**BID # CON 19-03**

**ADDENDUM NUMBER 02**

**NHTI Institute Drive Roadway Work & Campus Sidewalk Improvements  
on the NHTI Concord's Community College campus, a Component  
of the Community College System of New Hampshire  
26 College Drive, Concord, NH  
March 6, 2019**

**SHEET C-4**

**TYPICAL ROAD SECTION**  
NOT TO SCALE

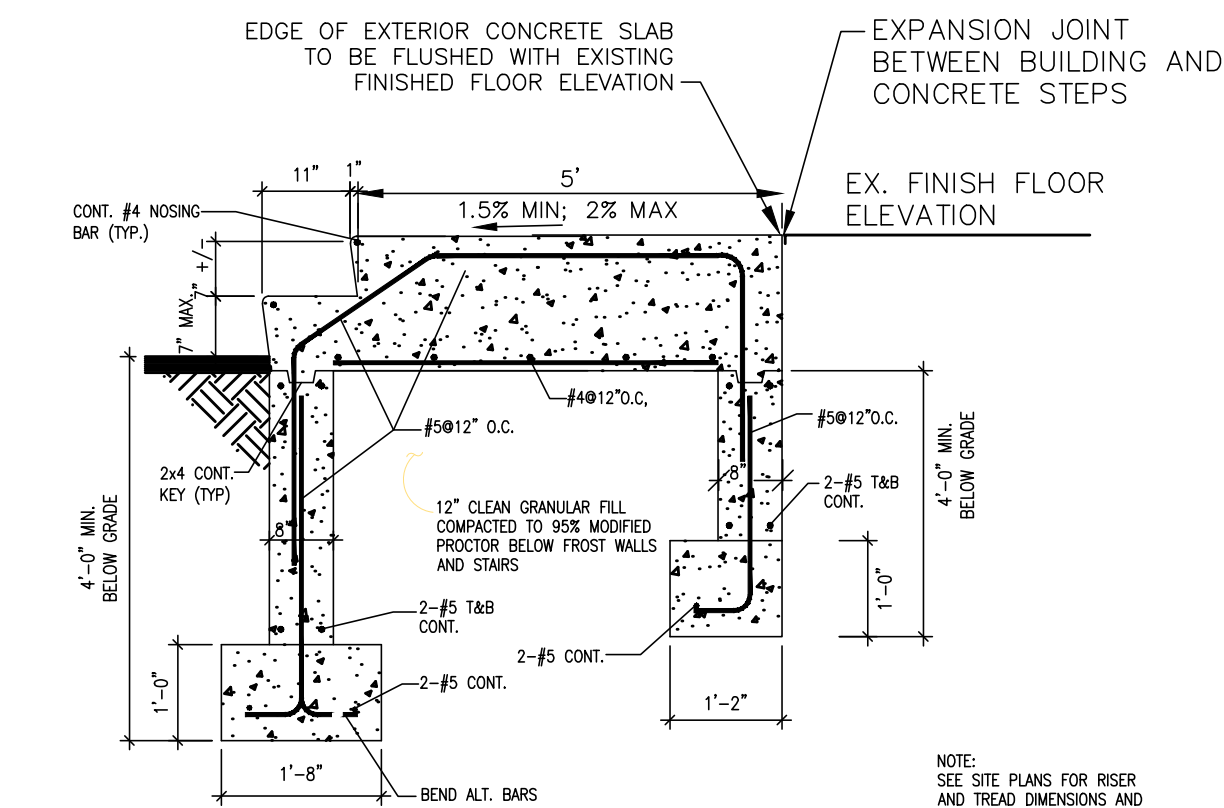
**QUESTION: 9.** The typical road section on sheet C-4 shows a 6 inch layer of 304.3 with a 2 inch base layer of pavement and a 1 inch wearing course. the road way cross sections show a 12 inch layer of 304.3 with a 2.5 inch base layer with a 1.5 inch wearing course. Which is the correct detail?

**ANSWER:** See attached "Sheet C-4 Construction Details" revised "TYPICAL ROAD SECTION" detail.
